Service Bulletin

No. : MZ05-004

Model: CD6000, CD6000F

Subject: Cannot Playback hybrid Super Audio CD (CD portion)

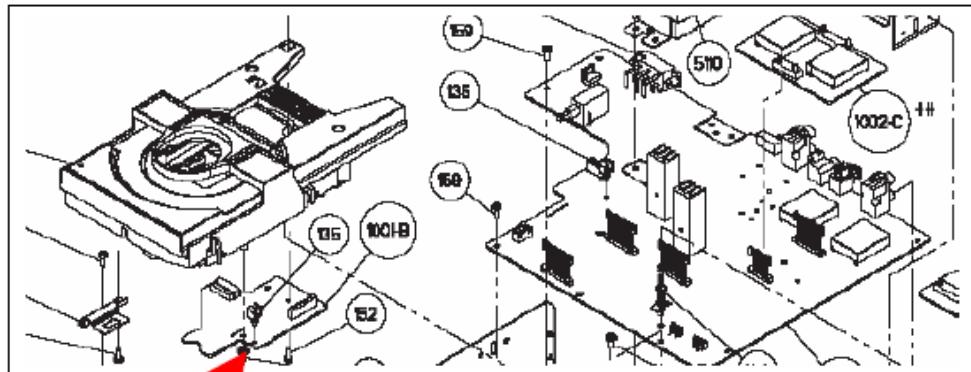
Symptom: Can not playback the CD portion of a hybrid Super Audio CD.
"ERROR" is indicated on the display when attempting to playback the CD section.

Solution: The following 4pcs have been changed on the HF AMP CIRCUIT BOARD:

1. Ref. # 3504 CHIP RESISTOR (22K OHM) is changed to (18K OHM).
2. Ref. # 3505 CHIP RESISTOR (10K OHM) is added.
3. Ref. # 2510 CHIP CAPACITOR (10pF 50V) is added.
4. Ref. # 2509 CHIP CAPACITOR (10pF 50V) is removed.

Attention:

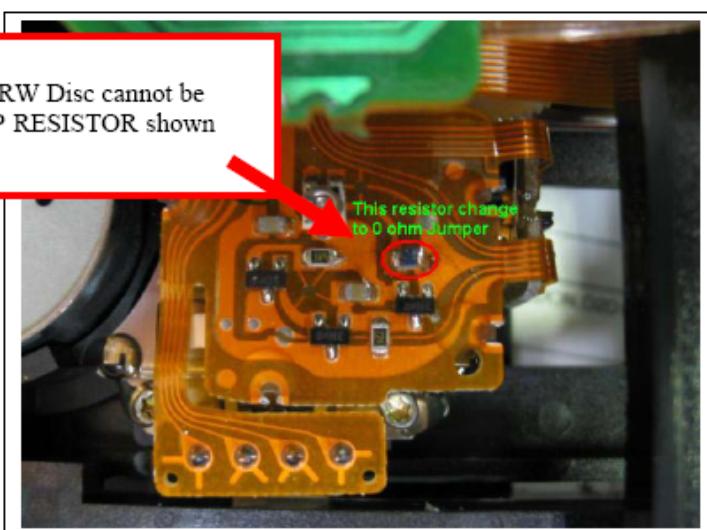
After you change the 4 parts if a CD-RW Disc cannot be Played back, please change the CHIP RESISTOR shown to a **"0 OHM Jumper"**.
